DRAFT MODIFICATION REPORT
MODIFICATION PROPOSAL P87 -
Removal of market risk associated
with the operation of a generator
intertrip scheme

Prepared by ELEXON on behalf of the Balancing
and Settlement Code Panel

Document Reference P087RR

Figure 1. Relationship between "Intertrip-affected Period" and "Initial Intertrip-affected Settlement Period" for the Proposed and Alternative Modifications.

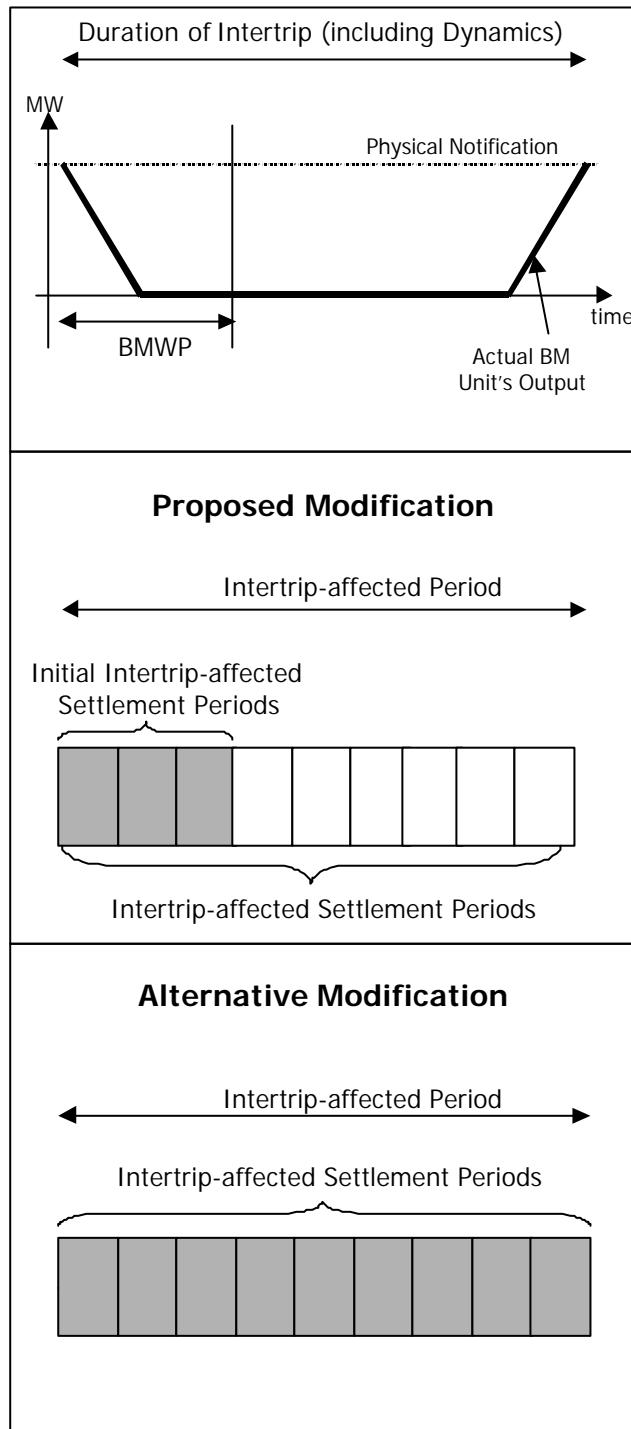
The Proposed Modification seeks to issue ex-post contract notifications for all Settlement Periods for which the Gate Closure had occurred at the time of the intertrip (i.e the BMWP). As shown from figure 1 the relevant Settlement Periods are referred to by the new Code term "Initial Intertrip-affected Settlement Period". This ensures that the affected BM Unit is not exposed to imbalance in the BMWP.

Furthermore, if the commercial consequences of the intertrip operating go beyond the BMWP, and the BM Unit is not compensated through a balancing services agreement then the affected BM Unit can take a claim to the Panel for extra compensation to cover costs over the whole "Intertrip-affected Period" (see figure 1). An affected BM Unit will be able to claim extra compensation under the following categories:
